TYPICAL SECTIONS KENYON ROAD - JOHNNIE BROOK ROAD

TYPICAL SECTION SHEET #2

PROJECT NAME: RICHMOND	PLOT DATE: 8/25/2011
PROJECT NUMBER: STP-RS 0284(II)	DRAWN BY: C.A.K.
FILE NAME: z90c092_TYP_I4.dgn	CHECKED BY: D.E.G.
PROJECT LEADER: D.E.G.	SHEET 3 OF 46
DESIGNED BY: B.T.H.	
DWG. NO.: TS-2

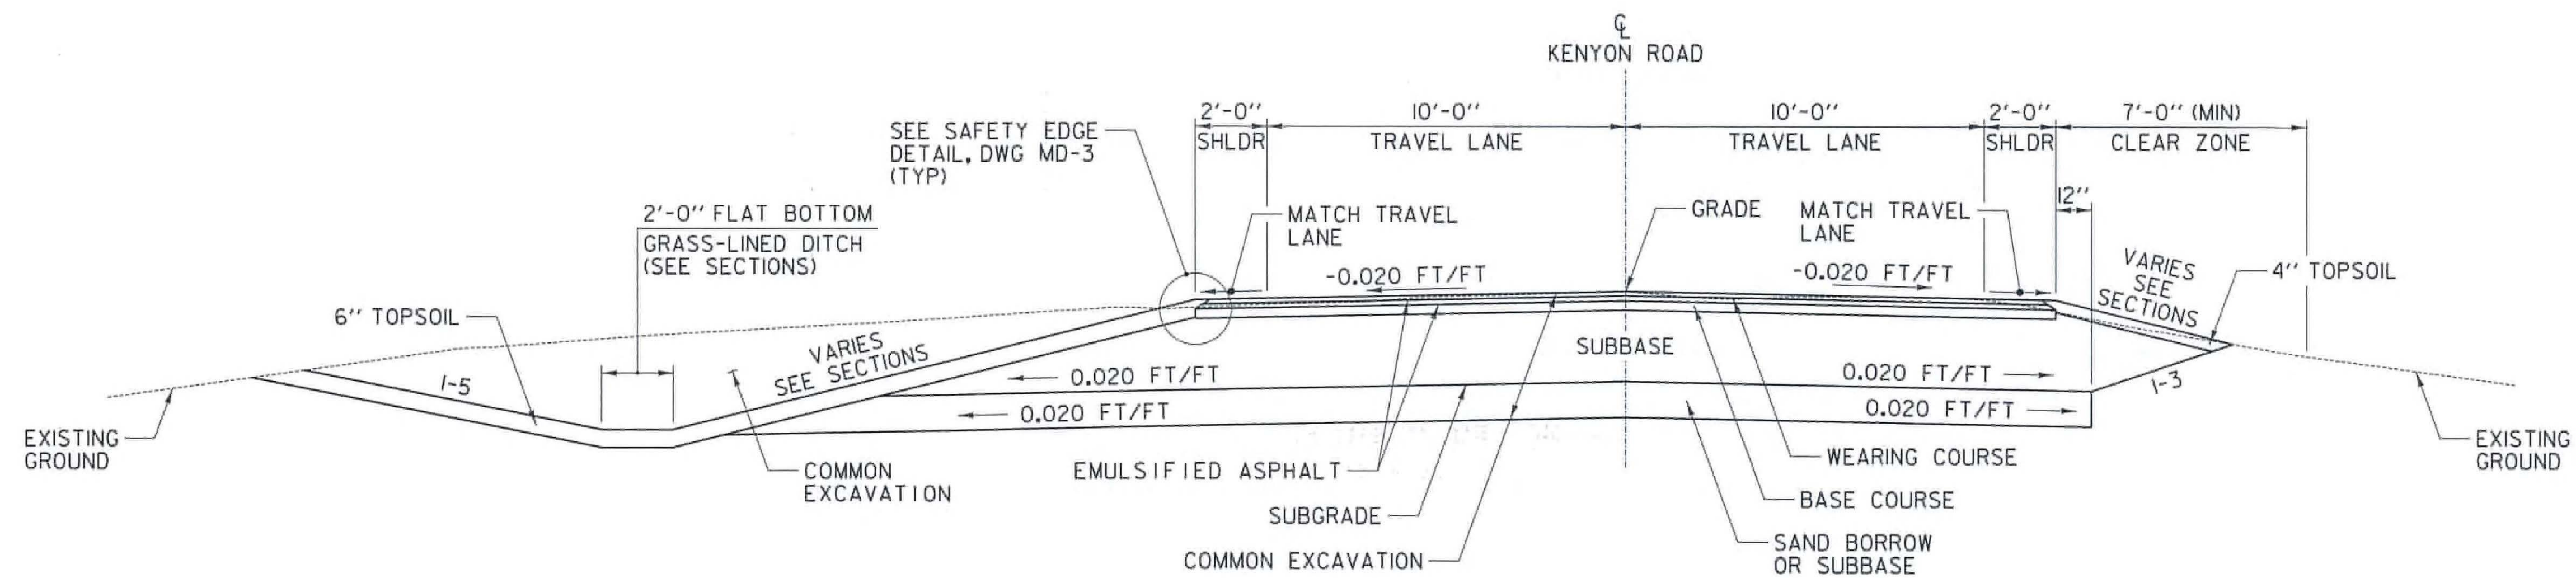
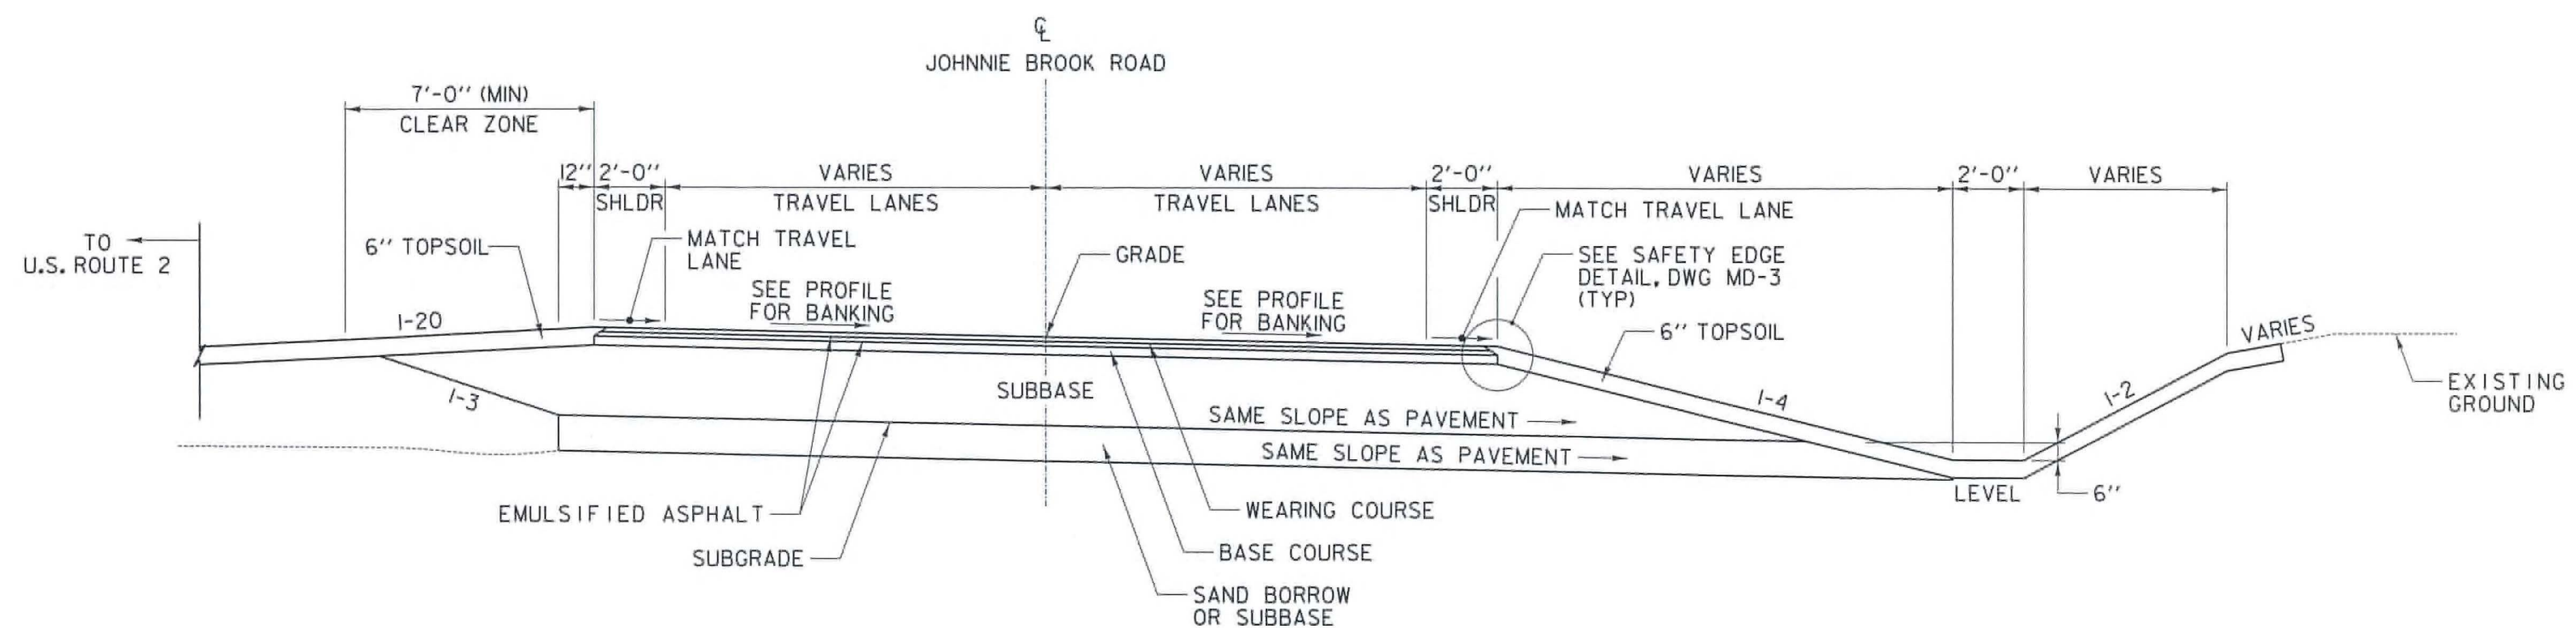
3" WEARING COURSE, SUPERPAVE BITUMINOUS CONCRETE PAVEMENT (PG 58-²⁸34), 1/2" TYPE III, 1/2" TYPE III S
 3" BASE COURSE, SUPERPAVE BITUMINOUS CONCRETE PAVEMENT (PG 58-²⁸34), TYPE ~~IS~~ ^{IS}
 24" SUBBASE OF DENSE GRADED CRUSHED STONE
 12" SAND BORROW OR SUBBASE OF DENSE GRADED CRUSHED STONE
